CONTRACT CHANGE ORDER NO. 194S1
SHEET 2 OF 2

SAN FRANCISCO OAKLAND BAY BRIDGE
EAST SPAN SEISMIC SAFETY PROJECT

SKYWAY CLEANUP ITEMS

SKYWAY STEEL BARRIER JOINT

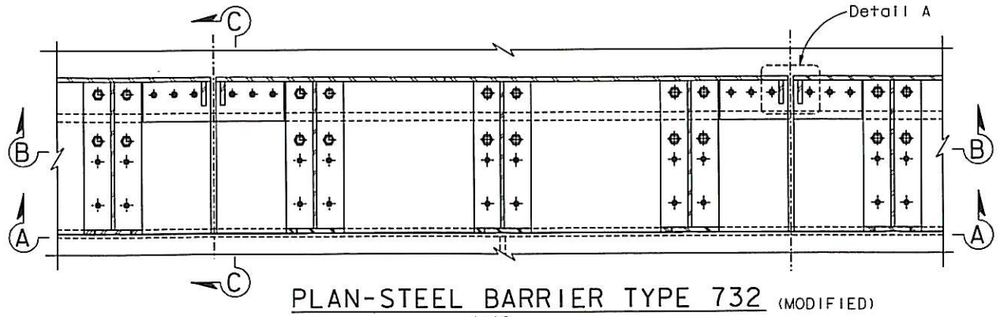
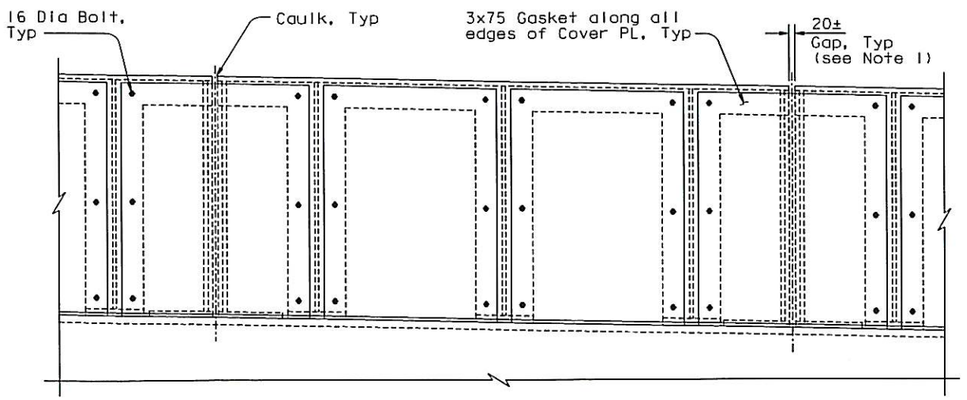
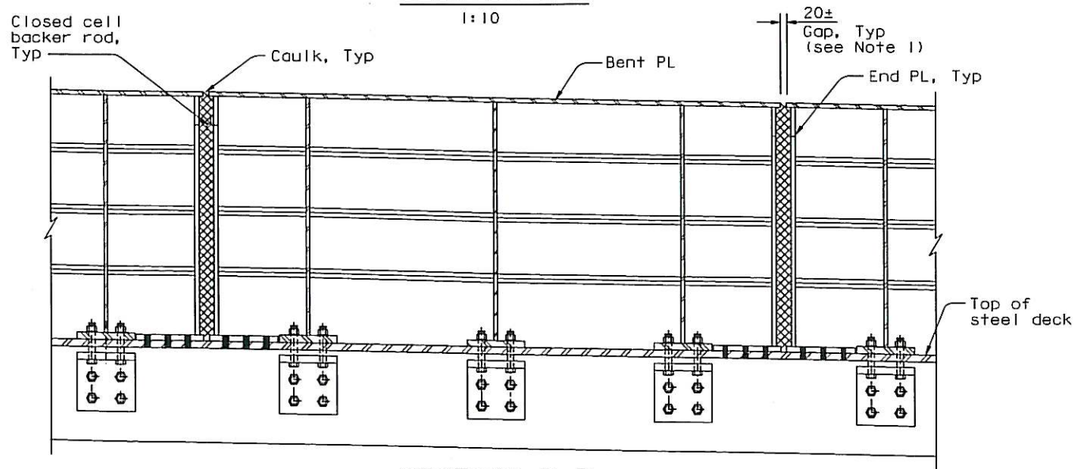
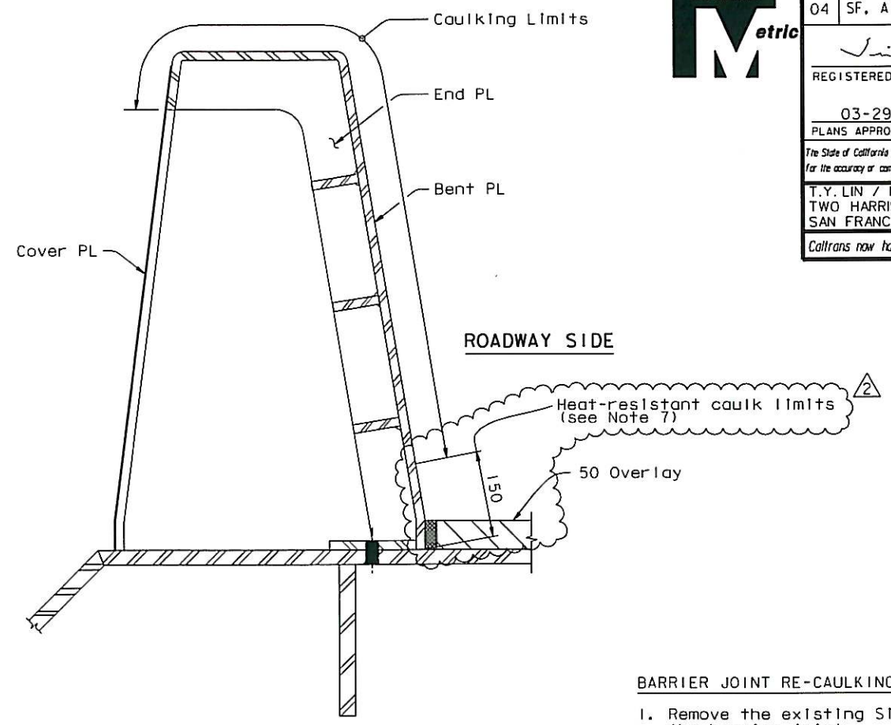
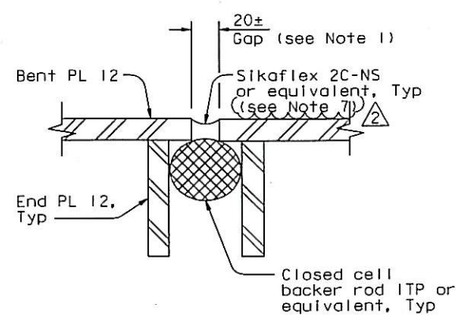
BARRIER JOINT RE-CAULKING PROCEDURE:

1. Remove the existing Sika Combiflex material from the barrier joint.
2. Clean and paint the exterior face of the Bent PL in the vicinity of the barrier joint. Clean and prime paint the edges of the Bent PL per manufacturer's recommendations.

3. Before installing the closed cell backer rod, clean the prime coated edges of the Bent PL with Xylene or Toluene, or as otherwise instructed by the manufacturer. Do not use Alcohol or MEK.

4. Install the closed cell backer rod (ITP Standard Backer Rod or equivalent). The backer rod material shall fit tightly between the End PL, leaving a 12mm deep x 20mm wide space for the caulk.

5. Caulk (Sikaflex 2C-NS or equivalent) the barrier joint and finish to a concave shape or as otherwise instructed by the manufacturer and approved by the Engineer.

6. Caulk shall match the bridge paint color, or as otherwise approved by the Engineer.
7. (2) Heat-resistant caulk (Dow Corning 732 or equivalent) shall be installed at the bottom 150 mm on the roadway side of the steel barrier vertical joints.
